SUBJECT: ABANDONMENT OF YOUR REQUEST FOR AMENDMENT DATED MARCH 21, 1991.

We have reviewed your letter dated March 21, 1991 requesting amendment to NRC License Number 12-16559-01 and find that we will need additional information as follows:

RE: AMENDMENT OF LICENSE #12-16559-01

SHEET #2

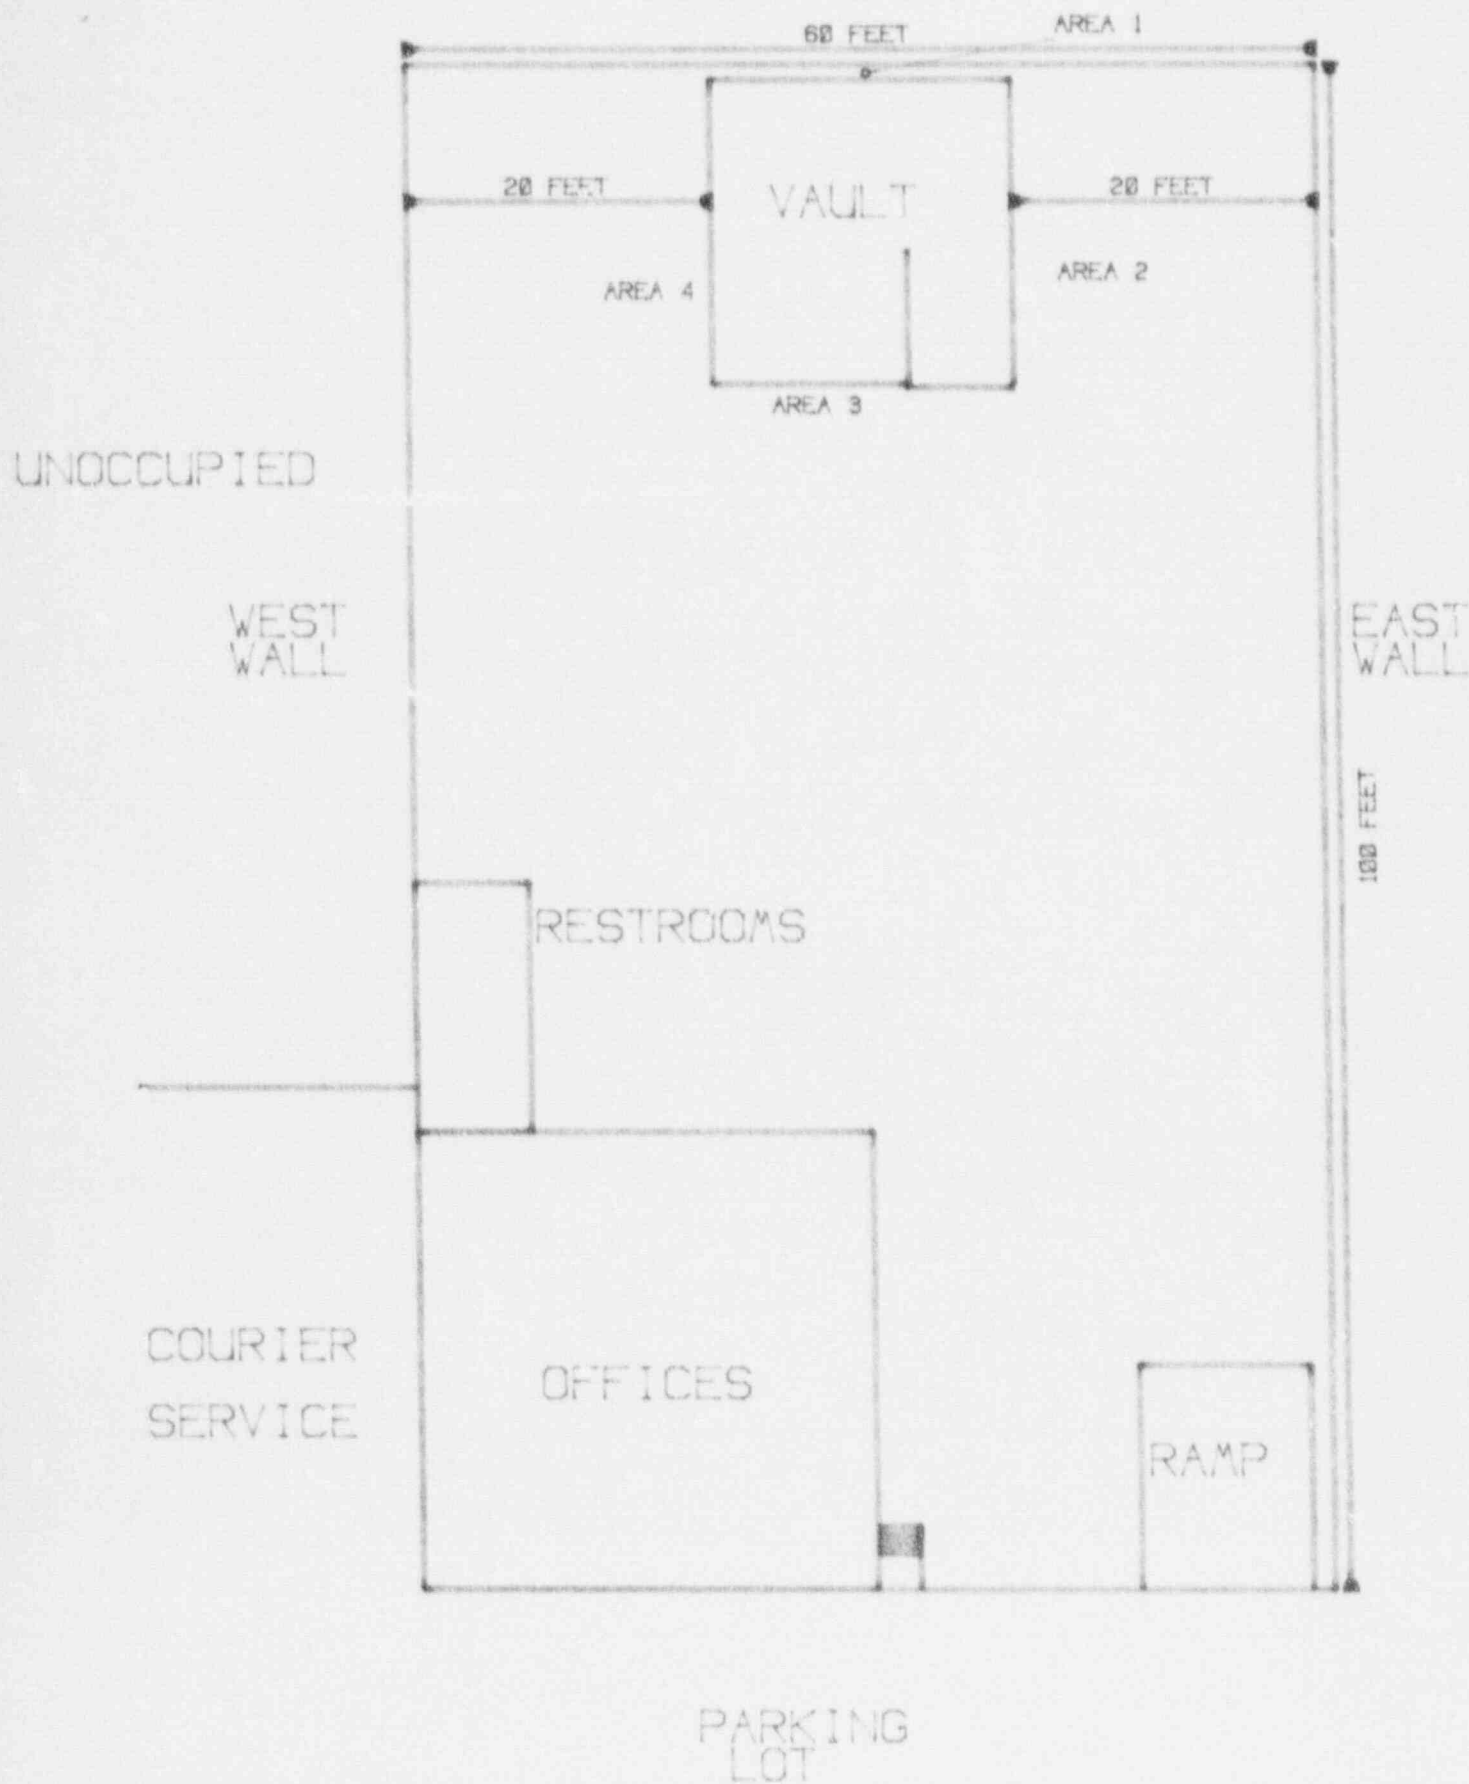
Submit the type, thickness, and density of shielding materials on all sides of the cell, including the floor and roof. Include a description of the nature of the areas above and below the cell. Diagrams may be helpful.

Submit the actual calculations used to arrive at the stated radiation levels in unrestricted areas (including above and below).

Describe, in greater detail, the shooting position and configuration of your worst case shot. Your calculations should be based on this description. Please clarify.

It appears from your submission that you will be performing radiography with Cobalt-60 only using a collimator. If our understanding is incorrect, then submit calculations that take uncollimated Cobalt-60 shots into consideration.
